Plan of
Lots 345, 1070-1079, 1146-1152, 1161 & 1162 and Proposed Emts A & B and Emts C-E in Lot 345 & Emts F-N in Lots 1070, 1072, 1074, 1076, 1078, 1146, 1148, 1150 & 1152 Respectively
Cancelling Lot 345 on SP287462

From: Jennifer Davison <Jennifer.Davison@dsdmip.qld.gov.au>
Sent: Monday, 10 September 2018 10:38 AM
To: [REDACTED] Devcon Building Co <[REDACTED]@builtbetter.com.au>
Subject: Further Issues - Lot 1146-1147 Aura Business Park

Client: DEVCN BUILDING Co.
Project: PROPOSED INDUSTRIAL DEVELOPMENT
LOTS 116-1147 HANCOCK WAY,
AURA PRECINCT 3 - STAGE 1

DRAWING TITLE
ELEVATIONS

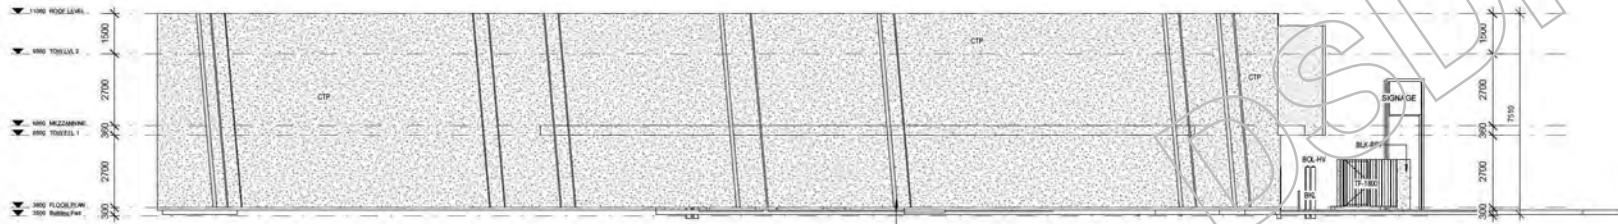
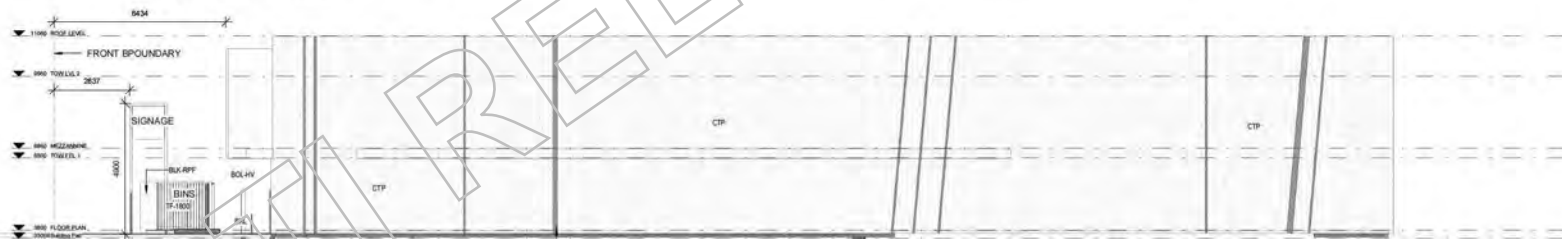
2. DS1.12 requires buildings to be designed to provide external wall colours and roof colour with a solar absorbance not more than 0.45 (i.e. avoid excess use of dark colours and zincalume). Confirm the intended roof colour complies with this design standard (it should be noted that the colour schedule was not provided as part of this application). **Confirmed roof will be "Shale Grey" with Solar Absorbency of 0.43. Have attached mood board showing colours.**

ROOF - COLOURBOND COLOUR 'SHALE GREY' (SOLAR ABSORBANCE 0.43)
